DESCRIPTIVE REPORT
(HYDROGRAPHIC)

Type of Survey ... HYDROGRAPHIC
Field No. ... RA-20-1-74
Office No. ... H-9443

State ... ALASKA
General Locality ... COOK INLET
Locality ... UPPER PORTION OF KNIK ARM

SUBJECT: Quality Control Report, H-9443 (1974), Cook Inlet,
Upper Portion of Knik Arm

Chart - 8553

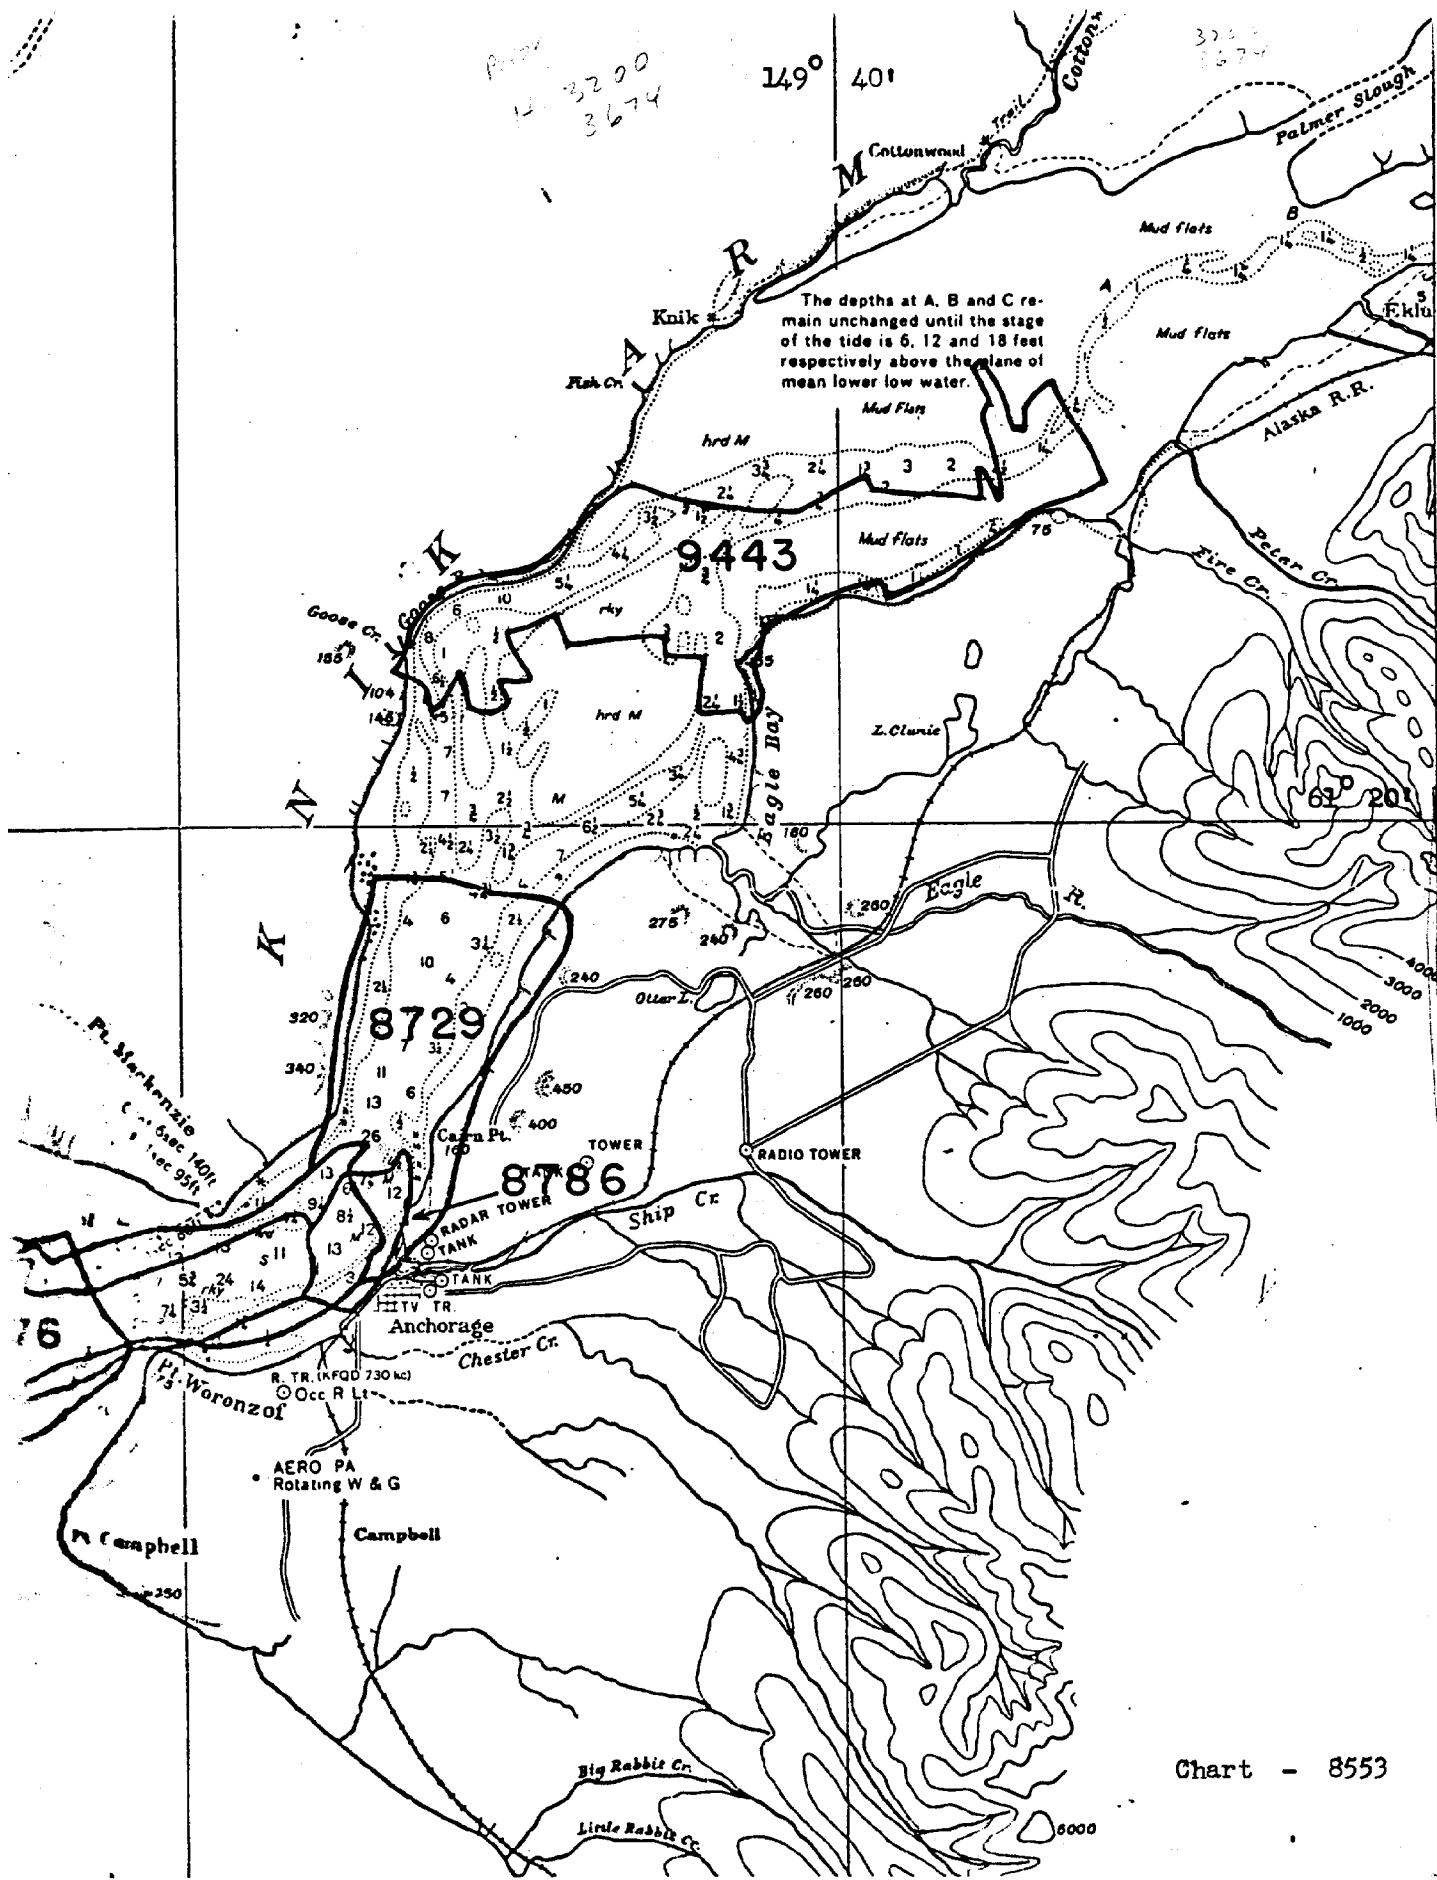
Recommendations for this note refer to D.R.
of H. 9443 (1974) page 8 TP's P and Q. ~~the~~ chart
8553 and 8557, affected.

Mariners should be aware of a tidal bore
beginning in the vicinity of Goose Bay ~~and~~
that heads northward up Knik Arm at a vel-
ocity of 2-3 knots and an average height
of 18 inches. In addition, it is noted that this
area is highly susceptible to shifting mudflats
and continual change.

OK to chart note - use hydrographic
survey as authority.

Mariners should be aware of a tidal bore beginning in the vicinity of Goose Bay that heads northward up Knik Arm at a velocity of 2-3 knots and an average height of 18 inches. In addition, it is noted that this area is highly susceptible to shifting mud flats and continual change.

Chart - 8553

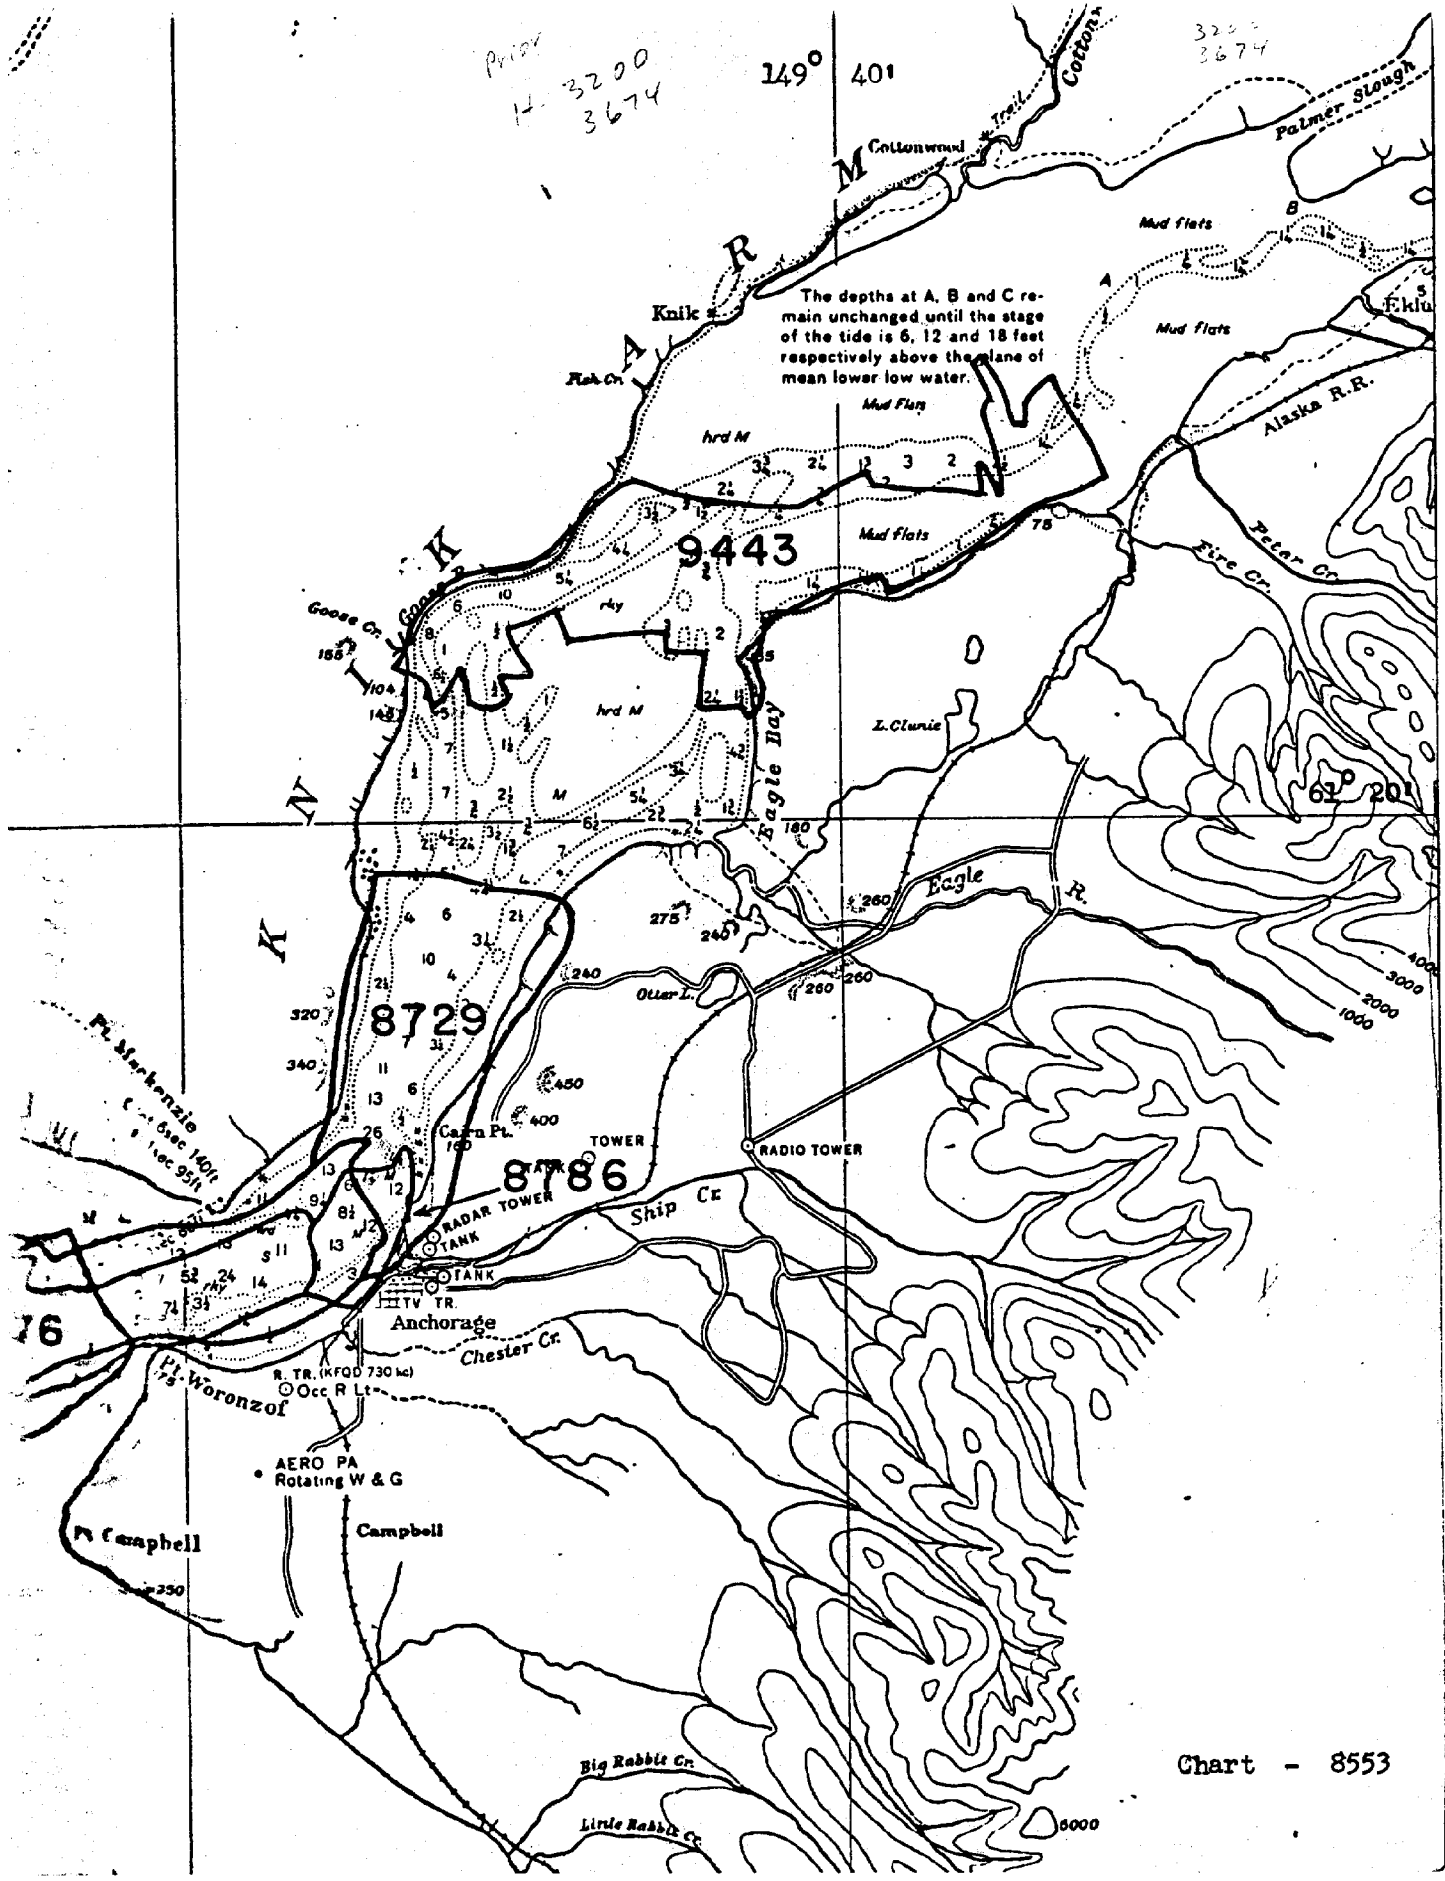
The depths at A, B and C remain unchanged until the stage of the tide is 6, 12 and 18 feet respectively above the plane of mean lower low water.
